Access Compliance Report Public Rights-of-Way (Pedestrian Signals)

Main Street: CERRITOS_AVE Cross Street: GILBERT_ST Location: SE

ADA ID: SGRK210923131405 Signal Type: One Push Button-Non APS Overall Compliance: No Severity Scores: BTN 1: 25 BTN 2: N/A No BTN: N/A

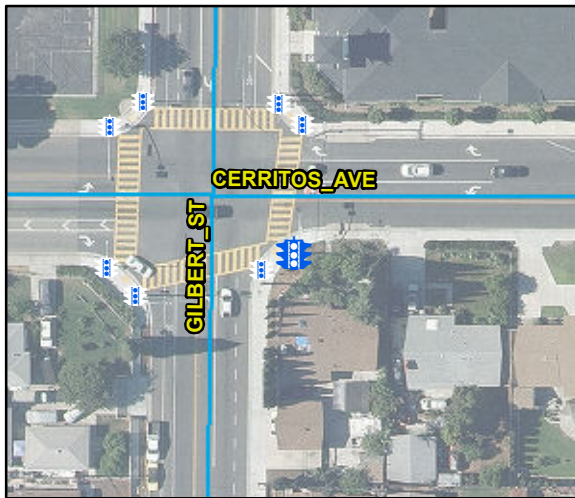
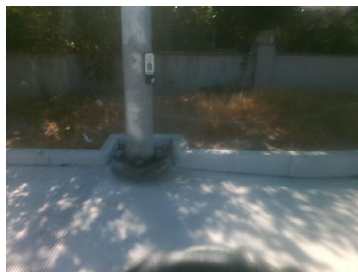
Yes B 1 Closed Fist Operation?	Yes	N/A	B 2 Closed Fist Operation?	N/A	
Yes B 1 Diameter (in)	2	N/A	B 2 Diameter (in)	N/A	
N/A B 1 Crossing Direction	N	N/A	B 2 Crossing Direction	N/A	
Yes B 1 DistanceTo XWalk (in)	25	N/A	B 2 DistanceTo XWalk (in)	N/A	
No B 1 DistanceTo Curb (in)	85	N/A	B 2 DistanceTo Curb (in)	N/A

Possible Solutions: Replace Signal Push Button With APS Button. Remove & Relocate Sign.

OC Std/PROW: MUTCD 4e.08, R404.2
